## City of Mississauga Department Comments

File(s): A184.23 Ward: 1

Property Address: 1502 Haig Blvd

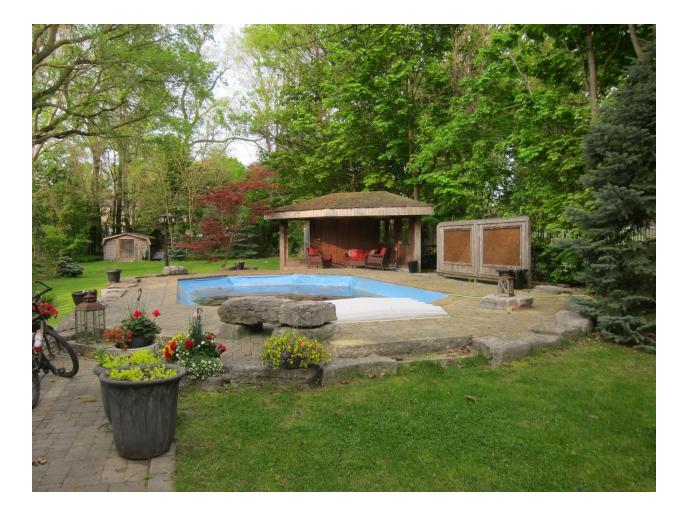
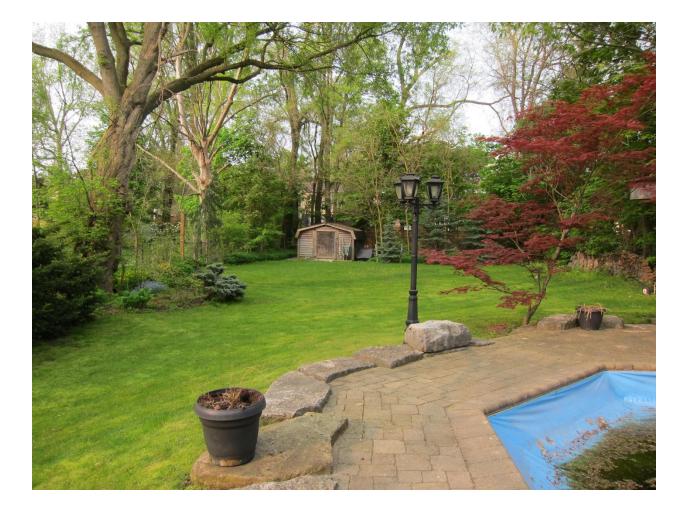
Our Traffic Planning Section does not support a circular driveway / secondary access for the subject site. As per the TAC Geometric Design Guide for Canadian Roads, "Single family residential properties [are] normally restricted to one driveway, irrespective of frontage." Consistent with Traffic Engineering best practices, the number of accesses to the municipal road network are to be minimized to optimize roadway safety and efficiency, minimize vehicular and pedestrian conflict points, ensure sufficient space is available between driveways for signage/utilities/trees/other street appurtenances, maintain on-street parking spaces, clearly identify which property each driveway serves, etc. If you have any questions on this matter, please call the Technologist (Michael Turco) directly at 905-615-3200 ext. 3597.
